**CITY OF SNELLVILLE
DEPARTMENT OF PLANNING & DEVELOPMENT
PLANNING COMMISSION**

CASE SUMMARY

CASE NUMBER: #SUP 22-01

DEVELOPMENT/PROJECT: Kidney Dialysis Center

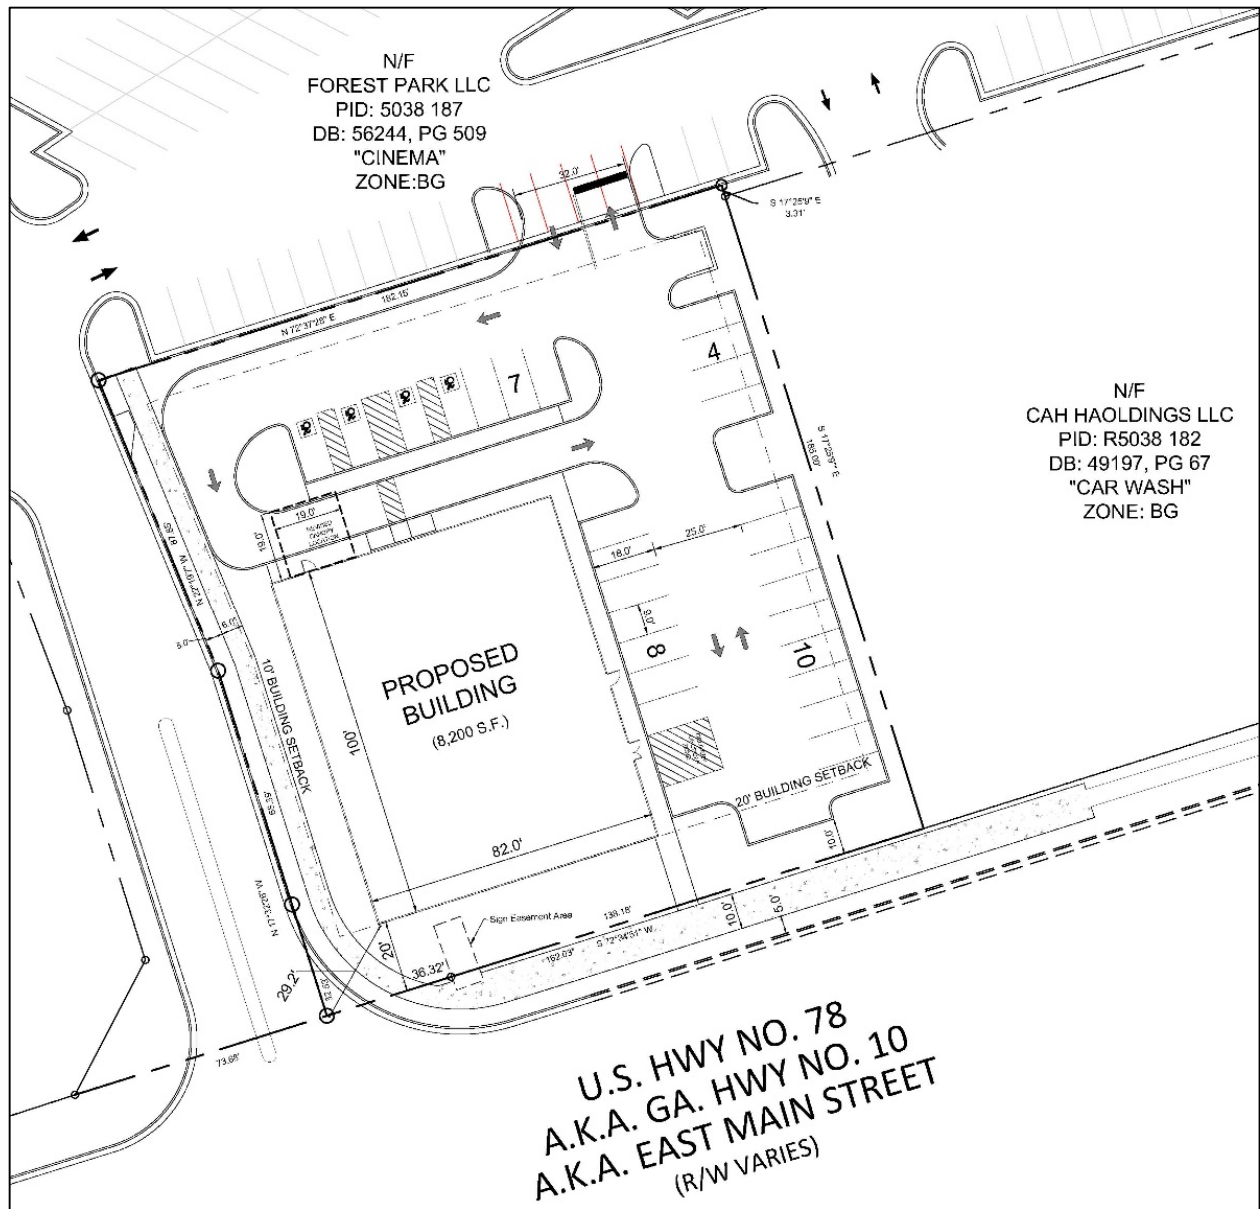
To allow the existing freestanding pylon sign to remain, the site plan indicates the building would be setback twenty (20) feet from the front property boundary/E. Main Street right-of-way and outside of the ten (10) foot maximum front building setback.

The site plan also indicates the building to be setback approximately twenty (20) feet from the lot line that runs along the curblin of the full-access *private street*ⁱ to the west.

The site plan does not show or account for any possible future right-of-way dedication or right-of-way improvements where adjacent to U.S. Hwy. 78 (E. Main Street); however, per UDO Sec. 401-5.2.F (Improvements along State Highways):

Because the front building setback indicated on the site plan is not in conformity with the requirements of the TCO District, the applicant is requesting a variance from the ten (10) foot maximum front yard setback requirement as described in the Variance Request and Analysis below.

A ten (10) foot wide sidewalk with five (5) foot planter is required adjacent to U.S. Hwy. 78 (E. Main Street). The site plan indicates a deviation from this requirement in the location of the existing freestanding pole sign. The applicant requests a variance from the requirement as described in the Variance Request and Analysis below.

The proposed sidewalk tapers from ten (10) feet down six (6) feet and continues along the private street adjacent to the western portion of the site while the planter remains five (5) feet in width in this area to allow for the planting of street trees and evergreen ground cover; decorative pedestrian lighting and other pedestrian amenities (bench, trash can, etc.).

Parking is provided along the eastern side of the building and in the rear of the building. Based on the size of the building, the minimum required parking spaces for the project would be seventeen (17) spaces. The site plan indicates four (4) handicap accessible spaces and twenty-five (25) regular spaces, for a total of twenty-nine (29) parking spaces would be provided, exceeding the requirement. Additionally, a delivery/loading space would be provided adjacent to the east side of the building. A parking lot landscape strip in accordance with Section 205-1.13.C of the UDO will be required between E. Main Street and the proposed parking lot.

Primary pedestrian access to the building would be provided in the rear, adjacent to the patient drop-off canopy. Additional pedestrian access is shown on the site plan to the side of the building adjacent the eastern parking. The UDO requires a building entrance facing the street for every seventy-five (75) feet of building façade to be connected to the street sidewalk with a minimum six (6) foot wide sidewalk. The applicant requests a variance from this requirement as detailed in the Variance Request and Analysis below.

The development will be required to connect to sanitary sewer, which is located on the parent shopping center tract, just north of the subject site. The site plan does not detail the proposed method(s) of stormwater management.

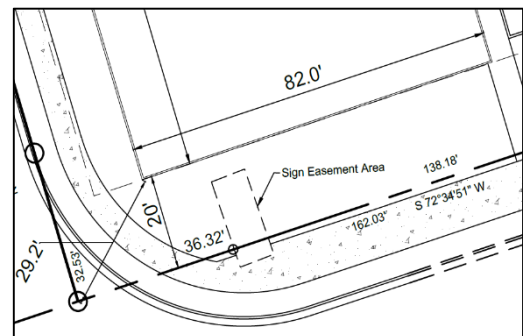
1. Applicant is requesting to increase the ten (10) foot maximum front yard building setback requirement to twenty (20) feet.

Variance Analysis: The applicant requests relief from the requirement due to the location of an existing nonconforming freestanding pylon sign that serves the parent tract retail shopping center.

Recommendation: The Planning Department understands the encumbrance the existing sign places on the development of this portion of the site; however, the existing sign does not meet current sign standards and a decision that would affect the life of a new building layout/design should not be based on the presence of a non-conforming pylon sign.

Additionally, as shown on the site plan, the sign easement area appears to encroach into the existing right-of-way of U.S. Hwy. 78 (E. Main Street).

- Applicant is requesting to reduce the sidewalk width along U.S. Hwy. 78 (E. Main Street) from ten (10) feet to six (6) feet as shown on the site plan in the area of the existing sign easement.

Variance Analysis: Included in the proposed #UDO 22-01 text amendment is the addition of the TCO District to Table 401-4.2 (Streetscape Table), requiring a minimum ten (10) feet wide sidewalk and associated five (5) feet wide planter strip where adjacent to roadways classified as Principal Arterial, in this case U.S. Highway 78.

Because of these factors, the Department of Planning and Development recommends **DENIAL** of the variance request.

Recommendation: The Planning Department recommends **DENIAL** of the variance for that portion of ten (10) feet wide sidewalk that requires a reduction due to the sign easement area for the existing shopping center pylon sign.

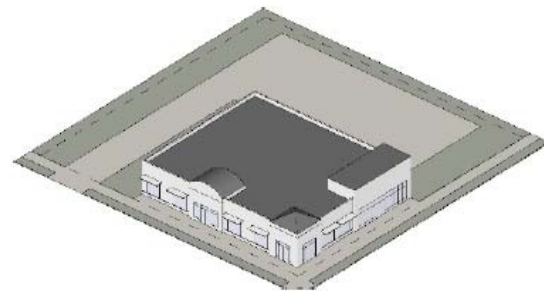
Variance Analysis: The applicant states in the letter of intent, that fenestration cannot be installed every twenty (20) feet of the street facing façade due to the location of the equipment and plumbing. The applicant also states the provided fenestration is 42.4%. Fenestration requirements for properties located on a State Route is a minimum of 30% and a maximum of forty (40) linear feet of blank wall area. Based on the elevation provided, the proposed building may meet the requirements.

Variance Analysis: The applicant states in the letter of intent, the need for relief of the requirement that a pedestrian building entrance must front on the street is based on the building orientation constraints.

The applicant contends that the TCO District setback requirements, which limit the building location closer to the street, necessitates the covered customer entrance be positioned on the opposite side of the building. Furthermore, the proposed building entrance location diminishes potential locations for equipment specific to the service the proposed business provides.

Recommendation: Based on the information provided by the applicant, the Planning Department staff does not believe a variance is necessary and therefore recommends **DENIAL** of the request.

Recommendation: The Planning Department staff recognizes the proposed business and subsequent architectural program accommodates a more automobile dependent client base.

The medical service industry is typically less pedestrian oriented than businesses typical of a downtown core. The project location adjacent to a Principal Arterial provides justification for leniency in regards to strict compliance of this requirement. The Department of Planning and Development recommends **APPROVAL** of the requested variance.
